# Broadcast Products Technical Bulletin 20-2008-093

SUBJECT: **HARDWARE CHANGES INCLUDED WITH  
VERSION 1.1 SOFTWARE**MODEL: **BVM-L230/1****DESCRIPTION**

BVM-L230/1 2,000,127 and Higher

*Figure 2*

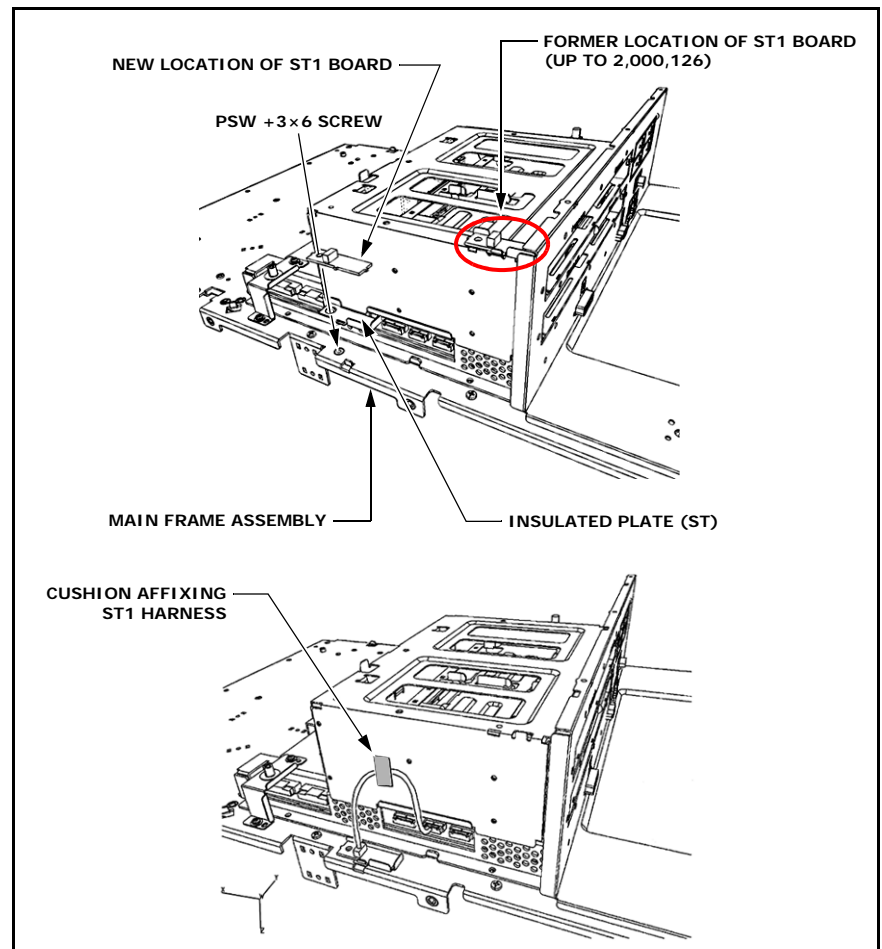
- The location of the ST1 board is changed to reduce impact to the temperature sensor with fluctuating set conditions. (See Figure 1.)
- The LVDS harness is routed differently to improve operation. (See Figure 2.)

The LVDS harness is routed as shown in Figure 2.

**Figure 1**

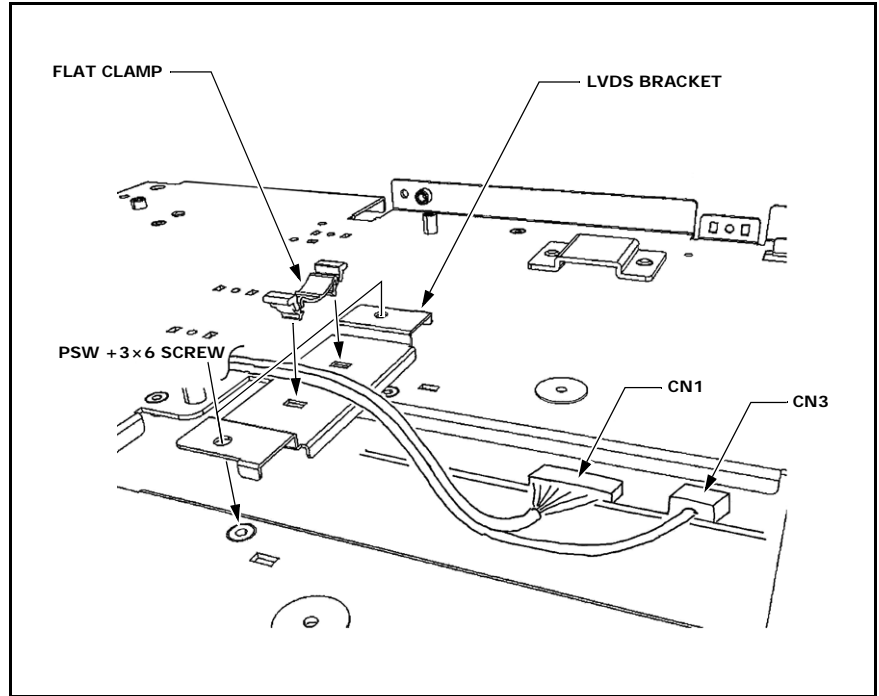
The new location of the ST1 board is as shown in Figure 1.
